Technical Service Bulletin

01 MIL on (DTC P2006(00) or P2007(00) stored in ECM)

01 13 11 2033919/6 June 26, 2013. Supersedes Technical Service Bulletin Group 01 number 13-06 dated June 18, 2013 for reasons listed below.

Model(s)	Year	VIN Range	Vehicle-Specific Equipment
A6/A7, S4, S5, S5 Cabrio, Audi Q7, Audi Q5	2013	All	3.0 FSI Engine

Figure 1. Vacuum pump VAS 6213

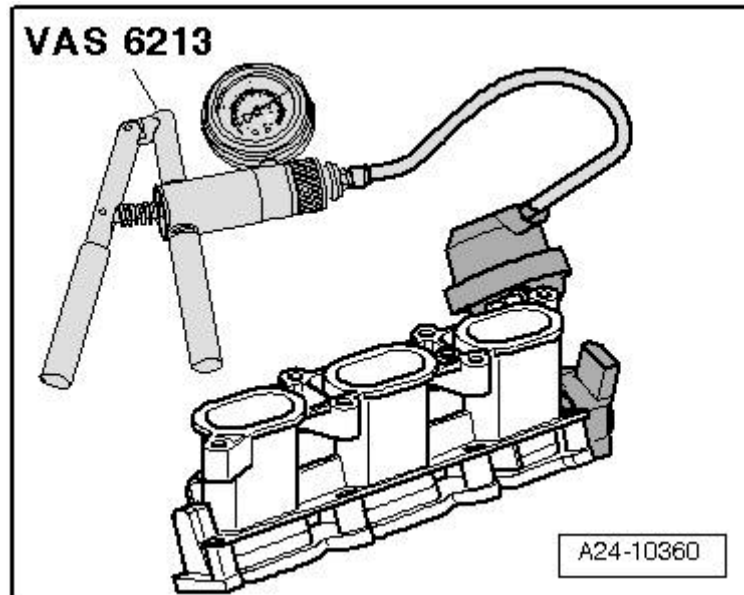
1. Ensure that the fault is not caused by a defective vacuum line by using the vacuum pump (Figure 1) to confirm there is no leak in the vacuum supply to the actuators.

The vacuum lines are working correctly if they are able to maintain vacuum while the actuators are disconnected and the lines are plugged up.

2. After confirming that the fault is not due to defective vacuum lines, replace **both** vacuum actuators (bank 1 and bank 2 actuator). This is to prevent any repeat repairs.
